Staff Report / Rapport du personnel

Subject / Objet : Recommandation pour l'emplacement d'une rue publique / Recommendation

File number / Numéro du fichier 26-0900

AMENDING SUBDIVISION PLAN
RONALD MARTIN SUBDIVISION
AMENDING PLAN 202301

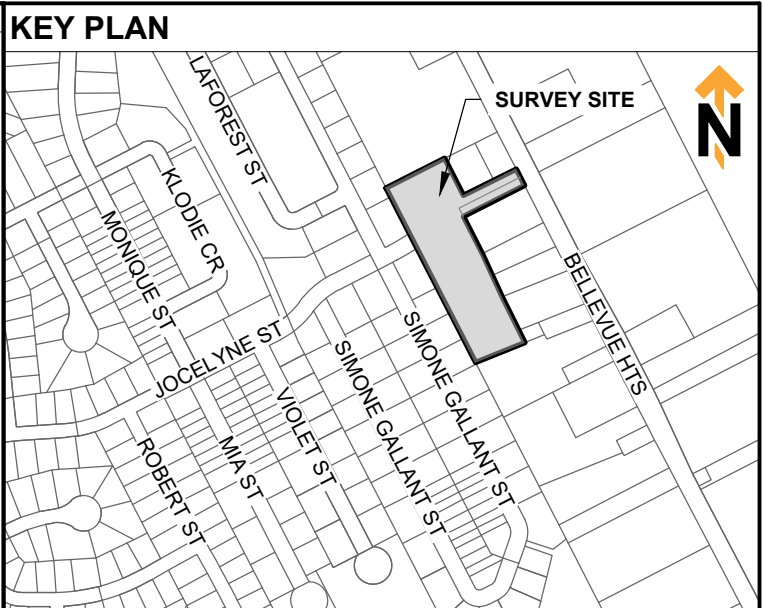
- L'entrée de stationnement desservant les lots 26-1002 et 26-1003 semble être partagée. De plus, certaines cases de stationnement semblent empiéter sur la ligne de propriété entre les deux lots. Si cette infrastructure est destinée à être partagée, une servitude privée (Private Easement / Right-of-Way) devrait être enregistrée sur les propriétés concernées et clairement identifiée sur le plan de lotissement.
- L'entrée de stationnement desservant les lots 26-1000 et 26-1001 semble également être partagée. Si cette infrastructure est destinée à être partagée, une servitude privée (Private Easement / Right-of-Way) devrait être enregistrée sur les propriétés concernées et clairement identifiée sur le plan de lotissement.

Il n'est pas nécessaire que ces servitudes soient établies à cette étape du processus de lotissement; toutefois, elles devraient être mises en place avant l'émission de tout permis de construction.

DRAWING TITLE
DRAINAGE PLAN

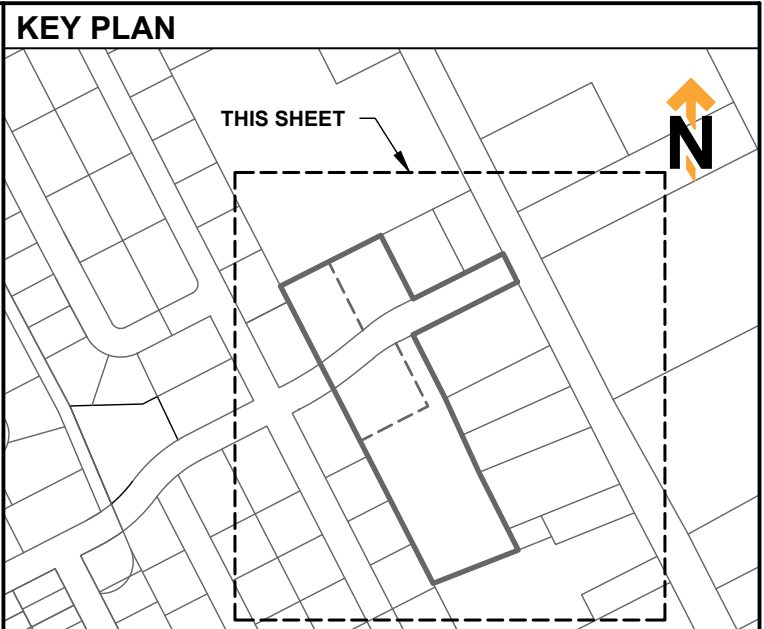
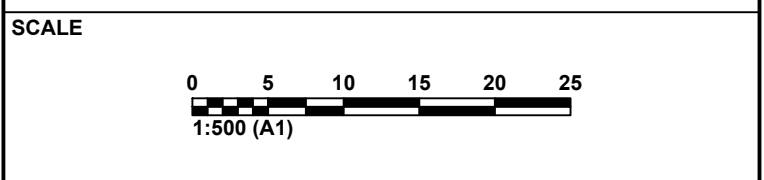
En ce qui concerne le drainage, je n'ai pas reçu de plan de drainage pour ces nouveaux lots. Je n'ai donc aucun commentaire spécifique à ce stade. Les exigences habituelles de la Ville en matière de drainage demeureront applicables lors de la soumission des plans détaillés.
